UNITED STATES PATENT AND TRADEMARK OFFICE

APPLICATION NO.	FILING DATE	FIRST NAMED INVENTOR	ATTORNEY DOCKET NO.	CONFIRMATION NO.
09/980,659	04/04/2002	Atsunobu Sakamoto	0112895-005	6654
40337	7590	01/04/2005		
NANCY A. PAPPAS 15210 AMBERLY DRIVE #1826 TAMPA, FL 33647			EXAMINER JEFFERY, JOHN A	
			ART UNIT 3742	PAPER NUMBER 14
DATE MAILED: 01/04/2005

Office Action Summary

DETAILED ACTION

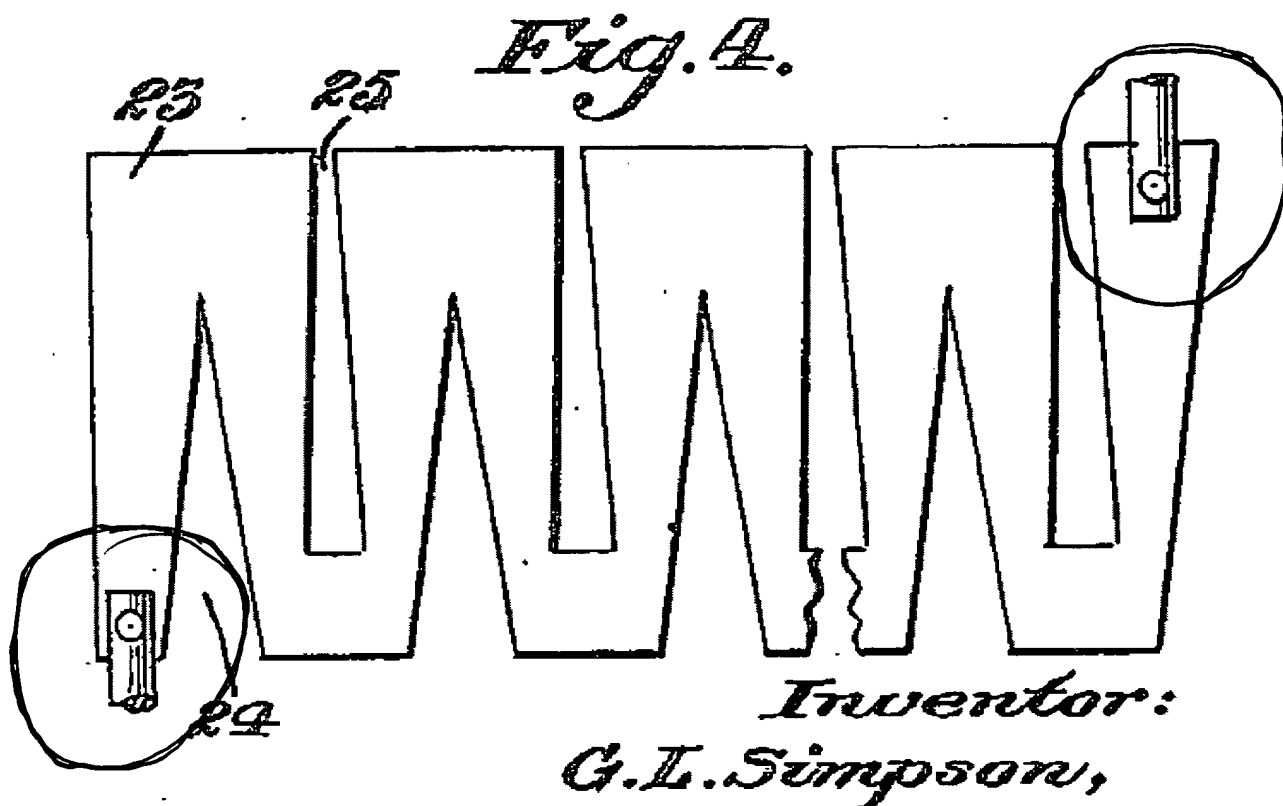
Claim 2 is rejected under 35 U.S.C. 103(a) as being unpatentable over Perrett (US 5,415,724) in view of Bohener (US 2,464,633) and further in view of Simpson (US 1,975,410). The claim differs from the previously cited prior art in calling for asymmetrical electrode portions. But asymmetrical electrode portions in electric heaters is well known in the art. Simpson (US 1,975,410), for example, discloses providing electrode portions for a serpentine electric heater 25 with unequally sized electrode portions. Compare the left electrode portion with the right electrode portion in Fig. 4 of Simpson (US 1,975,410), reproduced below for clarity:

Such an arrangement produces a non-uniform heating profile along the heater thus compensating for temperature non-uniformities during operation. See Page 2, lines 26-48. In view of Simpson (US 1,975,410), it would have been obvious to one of ordinary skill in the art to provide unequally sized electrode portions in the heater of the previously described apparatus to produce a non-uniform heating profile along the heater thus compensating for temperature non-uniformities during operation.
